# FCC Class II Permissive Change Request Letter

RE: FCC Permissive II Change Request for Company: Arize Corporation FCC ID: 2AWPP-ASH110

Network port component

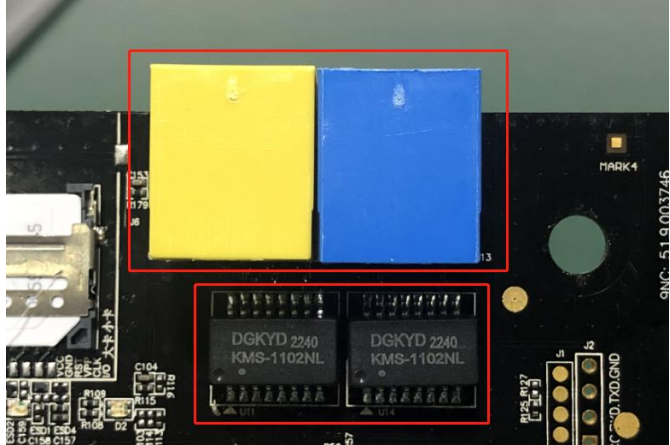
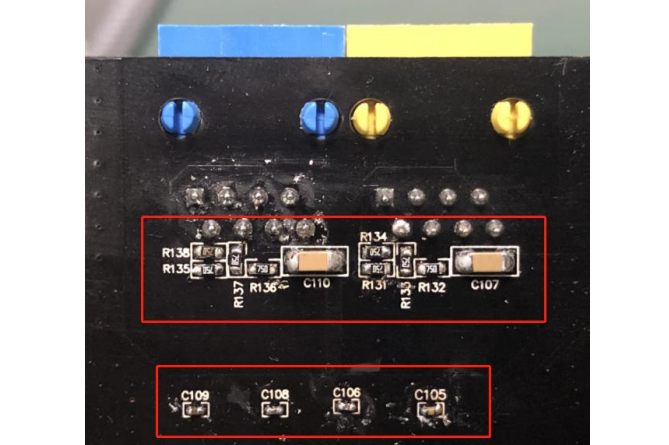
Add a network port assembly and peripheral resistor capacitor and a new adapter.

Network port IC, resistor and capacitor	New adapter
<p><b>IC:</b> U11, U14: KMS-1102NL</p> <p><b>Capacitor:</b> C105, C106, C108, C109: 0.1uF/10V C107, C110: 1nF/2KV</p> <p><b>Resistor:</b> R131, R132, R133, R134, R135, R136, R137, R138: 75R</p>
